Our Reference: P1427.002L

**RE : TWEED ULTIMA WHARF STREET – RESPONSE TO COUNCIL AND STATE GOVERNMENT
INFORMATION REQUEST**

This letter provides further information with respect to traffic element requests for additional information from the New South Wales Department of Planning and Infrastructure dated 24th December, 2013 (DA 456-10-2013 MOD 6) and the Tweed Shire Council dated the 20th December, 2013 (DA04/0016.16 LN22600). Our response is outlined below:

Figure 1: HRV Access into On-street Servicing Bay

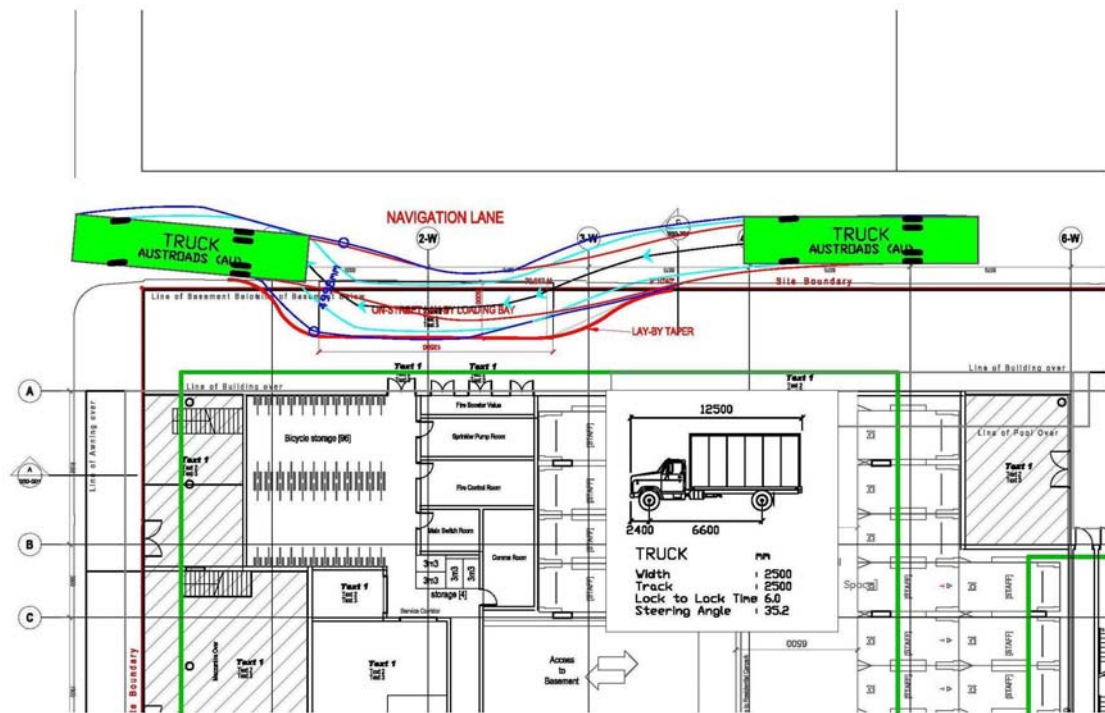
Service vehicle access to the Stage 2 building is proposed via a 'reverse in' arrangement off Navigation Lane. The Traffic Assessment notes that this arrangement is as per the original consent and is not expected to cause significant problems due to the service lane's "low traffic volumes and low speed environment" (p.11). Whilst it is noted that existing consent exists for the reverse in arrangement, it is likely that such a scheme would only be acceptable on the basis that Navigation Lane experiences very low traffic volumes. Given that the proposal will result in up to 78 additional vehicle movements per hour along the Navigation Lane, the proposed modification increases the likelihood of dangerous situations involving service vehicles blocking traffic attempting to egress the site. Such situations could be problematic as it would require blocked vehicles to reverse several hundred metres along Navigation Lane. This approach is undesirable as it would create dangerous situations for both motor vehicles and pedestrians. Given the existing arrangement for service vehicles to access Navigation Lane, reconsideration should be given to the current practicality of the basement level 1 connection to the Western constructed towers.

To accommodate service vehicle access to the site in a forward gear an "on-street" service bay has been included into the revised design. This loading facility maintains pedestrian footpath width. In addition, the "on-street" configuration allows use of the loading bay by surrounding sites and removes the need for loading facilities to be installed on Bay Street. The proposed indented service bay is proposed on Navigation Lane fronting the Stage 2 building and allows servicing access without impacting Navigation Lane traffic. The design of the service bay includes the following:

- 12.5 metre length at full width to allow standing access for a refuse collection vehicle;
- transition tapers for efficient forward ingress and egress bay access via Navigation Lane; and
- a 3 metre bay width to store a service vehicle clear of Navigation Lane through traffic.

The proposed indented service bay is considered an appropriate option for the site's servicing access requirements. The bay eliminates the need to reverse in a constrained area and results in an efficient use of space.

A swept path check for a Heavy Rigid Vehicle (HRV) access into the service bay is shown in Figure 1:
